Morlais Project

Terrestrial Ecology Assessment Update

Document Reference: MMC353 MOR-RHDHV-DOC-0110 (4)

Updated assessments for terrestrial ecology (excluding chough) in response to comments made on the Environmental Statement by NRW and RSPB – version 04

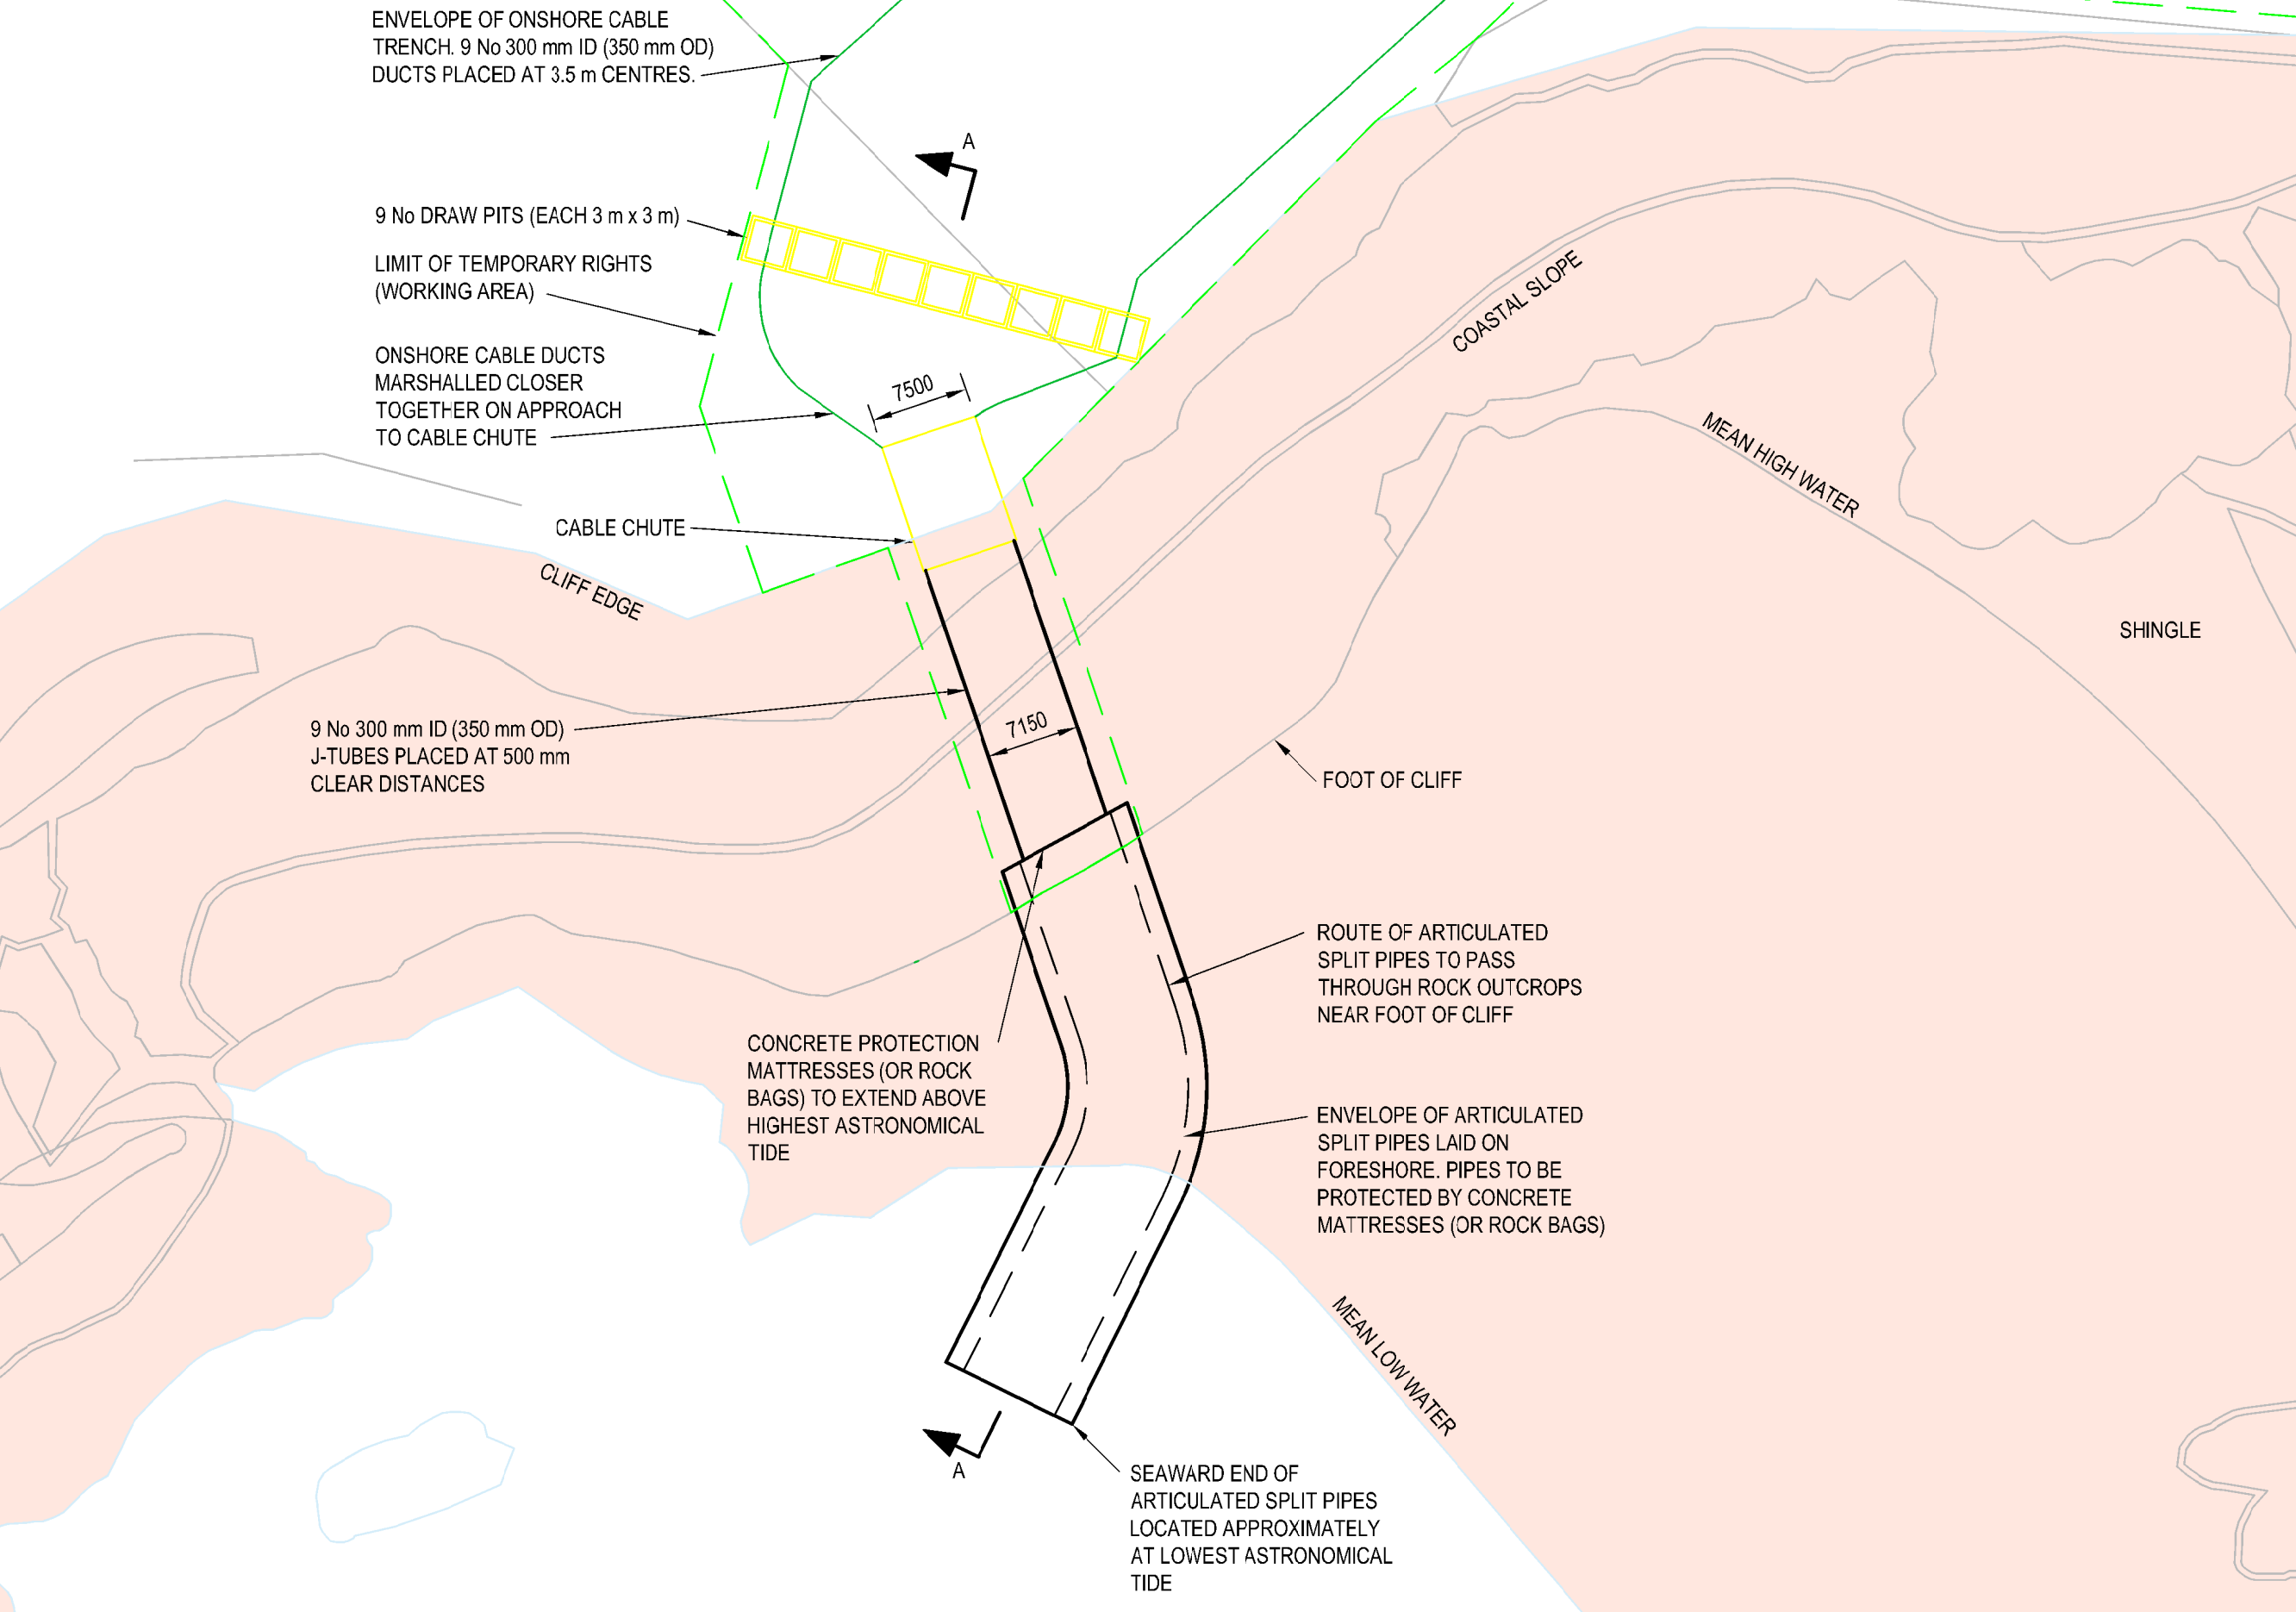
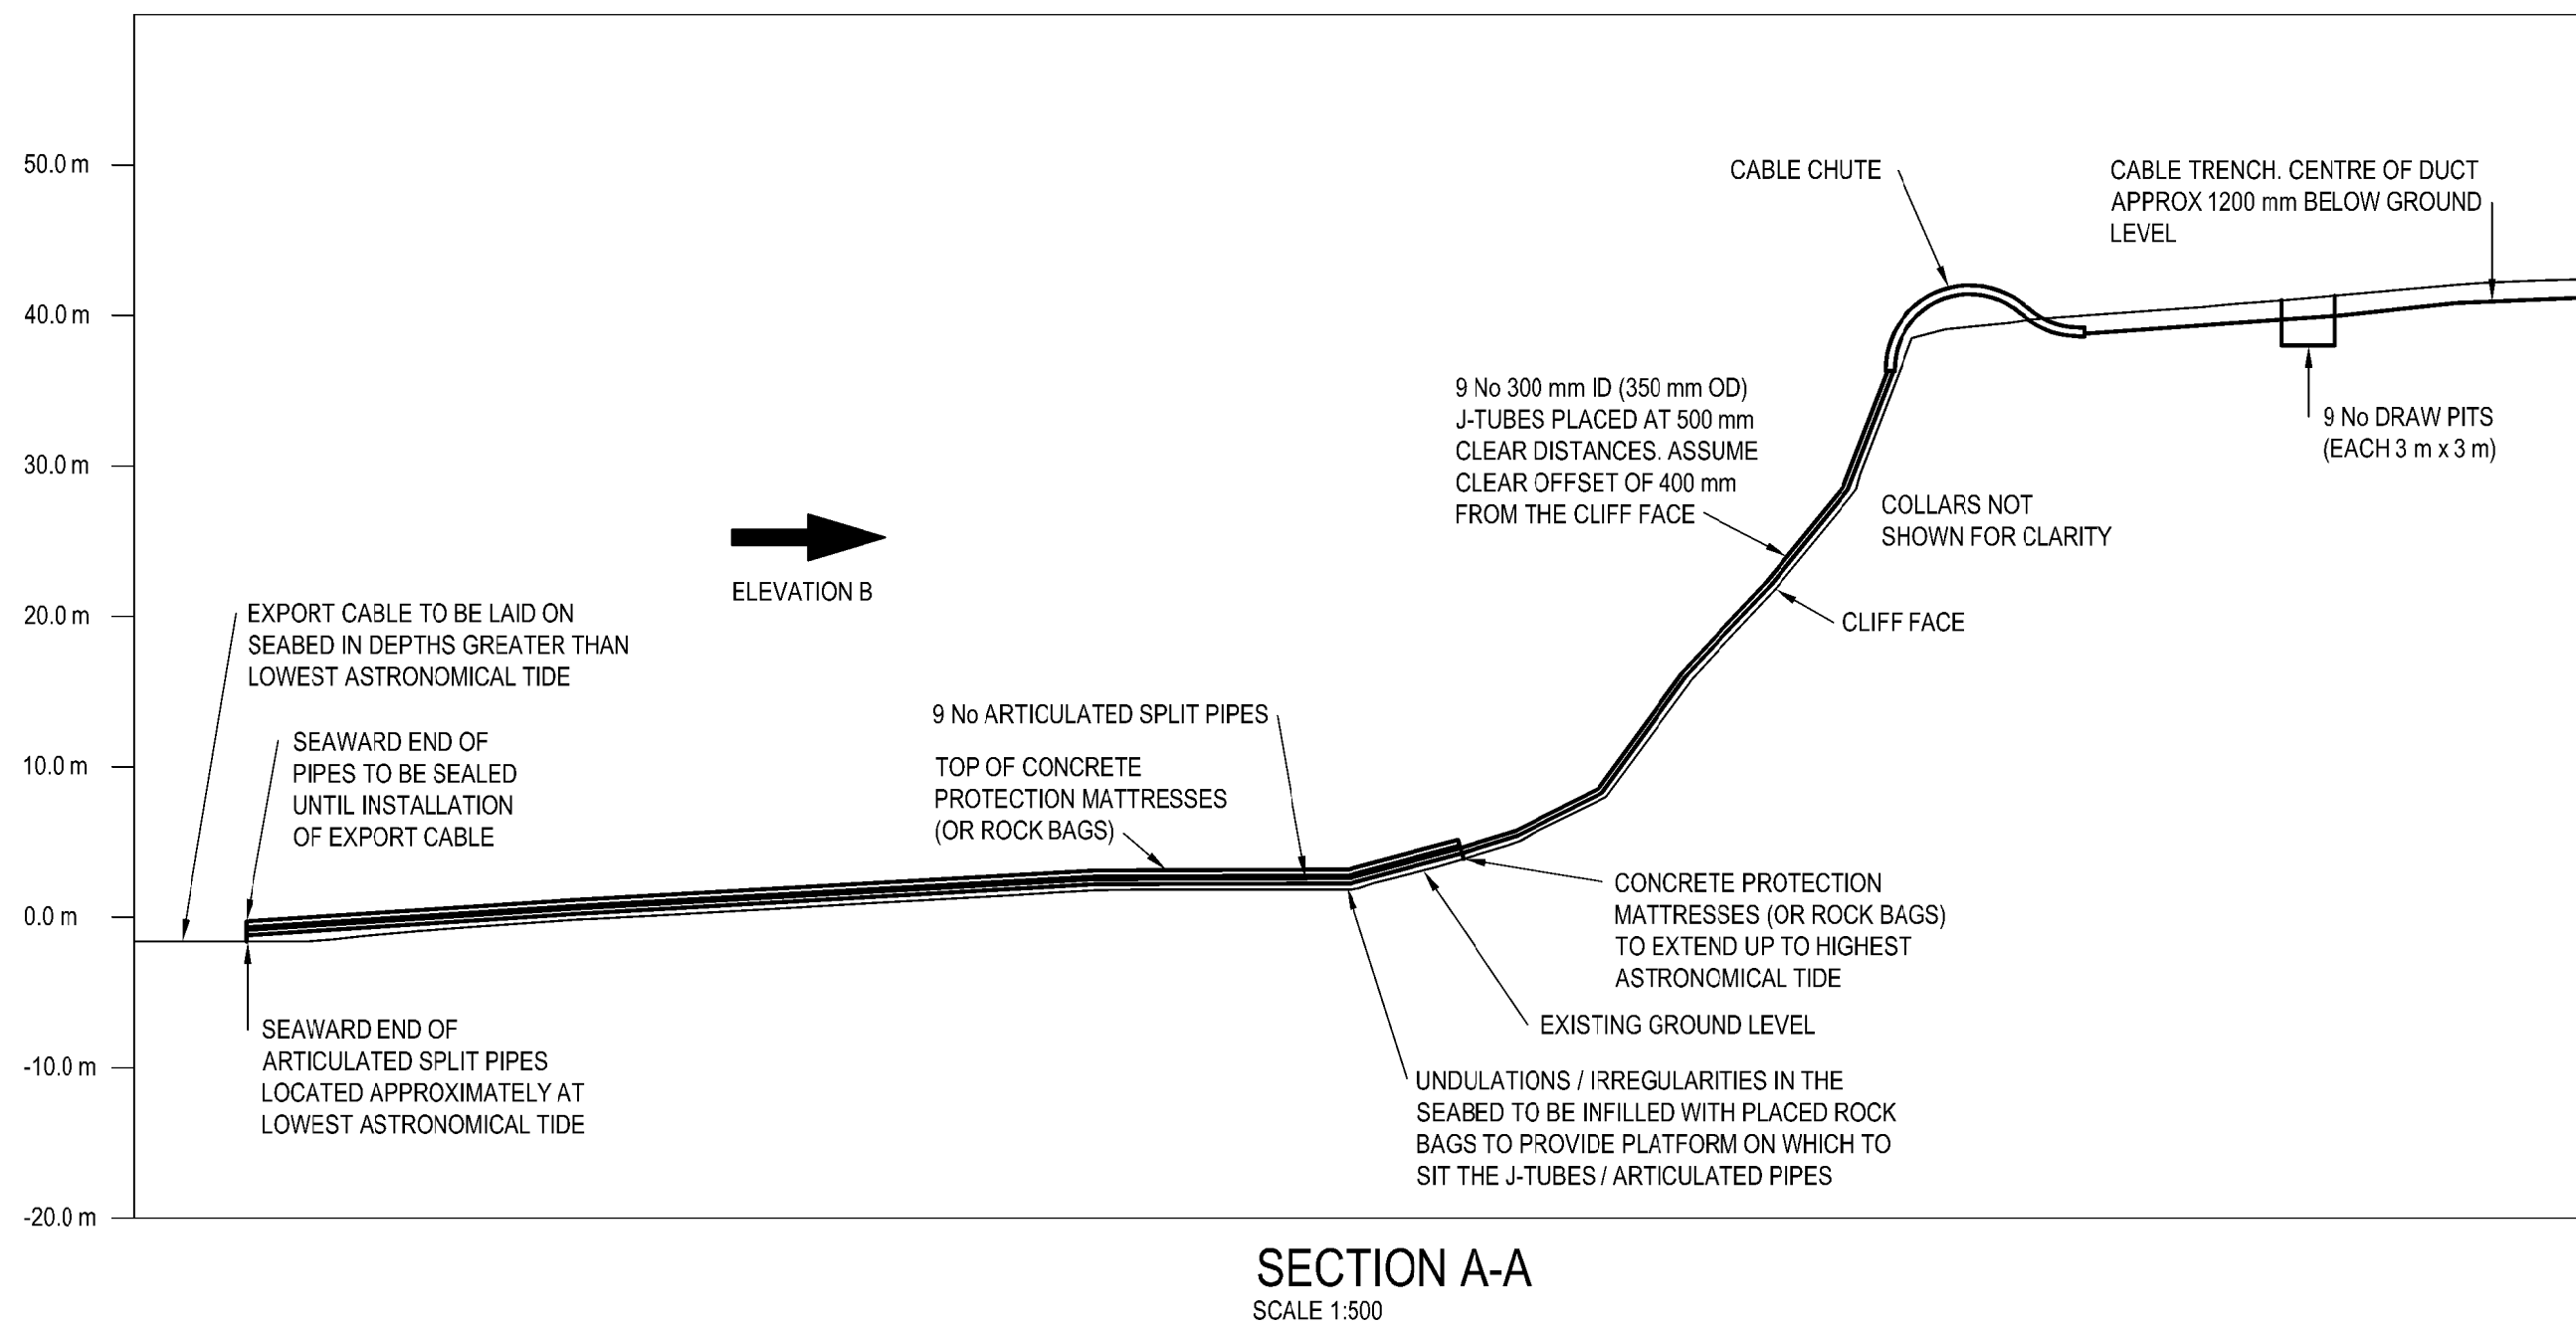
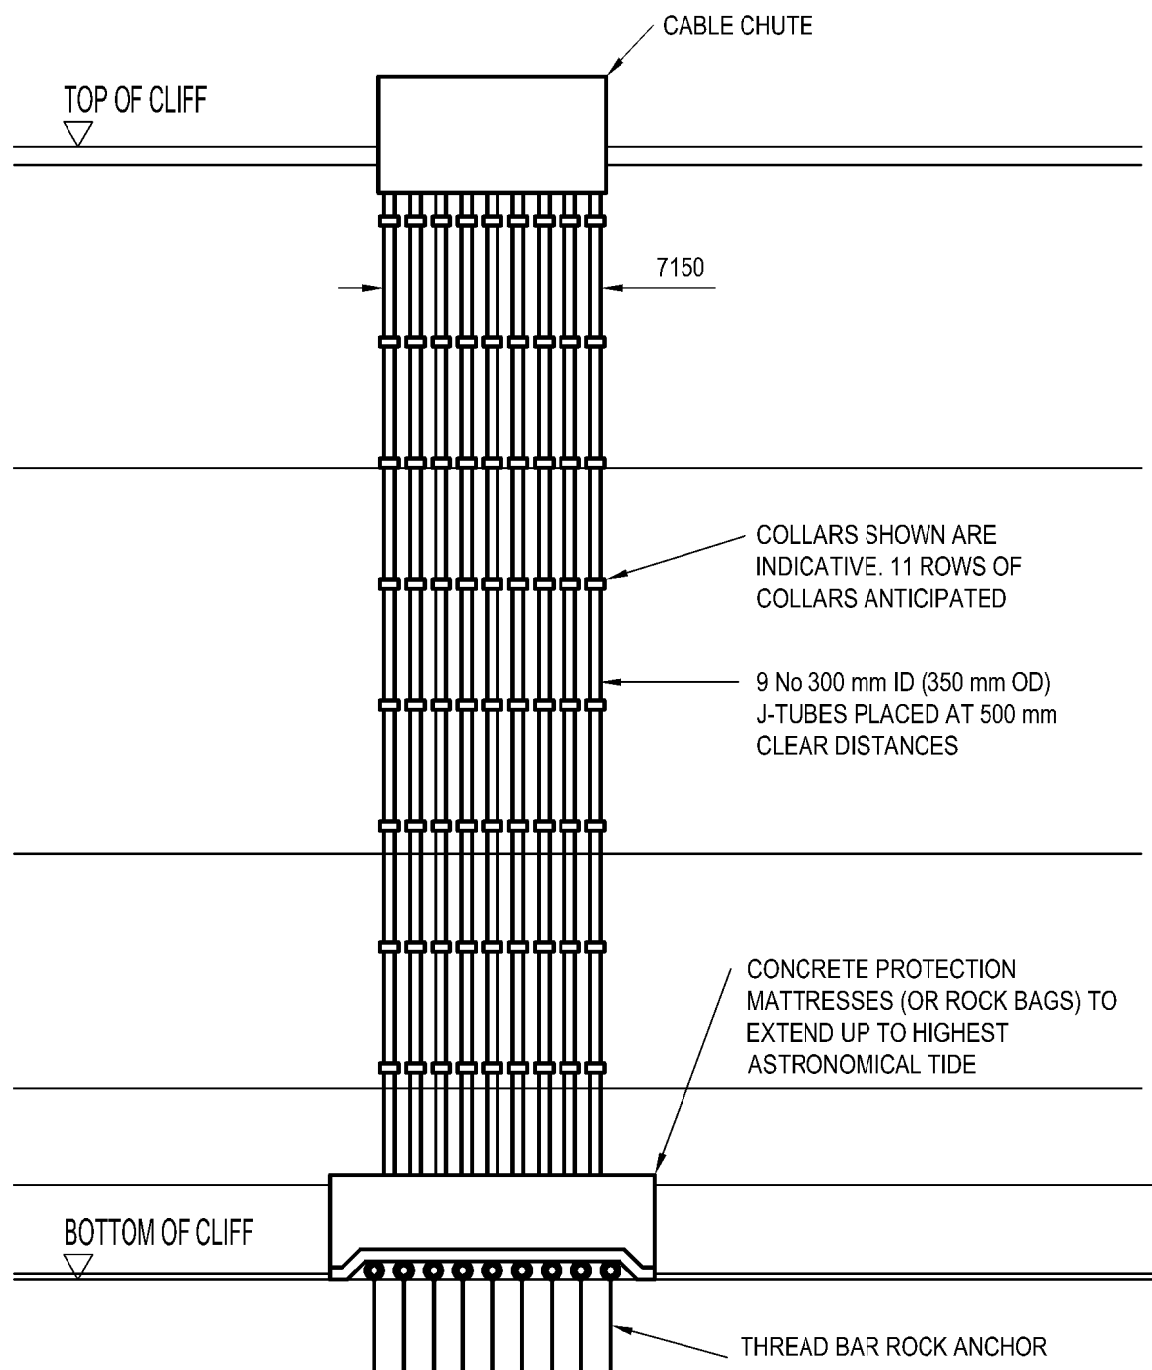
Comment Number	Comment Detail	Morlais Response
2	Drawing 2: Concrete apron at toe of cliff – up to Highest Astronomical Tide. There is a need to assess whether any qualifying SSSI features are present in this area: rockpools, caves and overhangs under boulders	These features do not appear on the citation for the SSSI https://naturalresources.wales/media/656113/SSSI_0963_Citation_EN001c75d.pdf
3	Drawing 2 shows the wrong SSSI boundary at the north-west end of the area where cables come ashore. It should follow mean low water but at c SH215815 the low water mark disappears and only the high water boundary is left.	Drawing 2 has been amended to better define the SAC boundary
4	The areas shown for stockpiles still seem quite small relative to the volumes of material to be stored, even allowing for opening trenches in short sections. Turf storage usually requires a lot of space.	For the construction phase of the project, a detailed Materials Management Plan will be developed by the contractor and submitted for acceptance by the client. All construction works will be programmed and undertaken to meet any planning and environmental constraints that are imposed on the works. It is however anticipated that the works will be phased to minimise environmental impact and disruption to local receptors. Construction of the works will be phased to suit available land take (e.g. stockpile and laydown areas) which will accommodate the temporary storage of turf as required. (See Section 5).
